SERVICE BULLETIN

Subject: S-Series Platforms: 34in. x 54in., 32in. x 51in.
Applicable Products: S1205, S2005, S2010, S5005, S5010, S5505, S5010
Effectivity: 6/24/2014

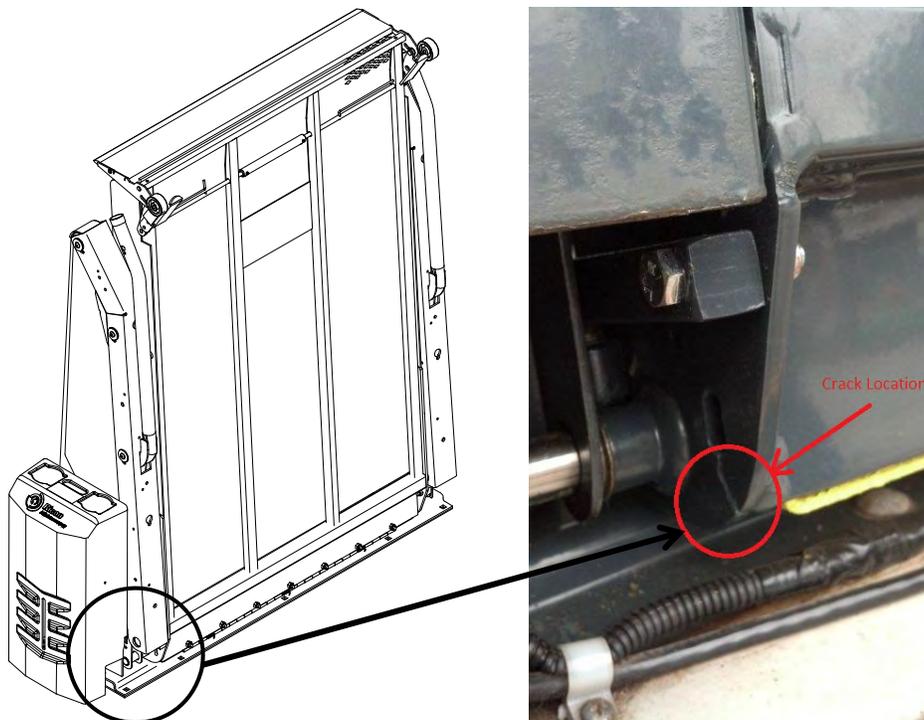
Under certain conditions the side plate of the larger platforms included on the subject S-Series model wheelchair lifts can exhibit cracking while in the stowed position which, if left unchecked can propagate to the point where separation of the rear portion of the side plate occurs rendering the lift inoperable and possibly unsafe to use.

The cracking as illustrated has been observed on less than 5% of the subject population and appears to be caused by a combination of factors including but not necessarily limited to, incomplete stowing of the lift and/or maladjustment or otherwise malfunctioning of the stow lock device combined with a violent side- to- side movement that might be associated with traversing curbs, speed bumps and other variable road conditions, especially at higher speeds.

If cracks are found, the platform must be replaced as soon as possible. Use the following part numbers for the associated model numbers.
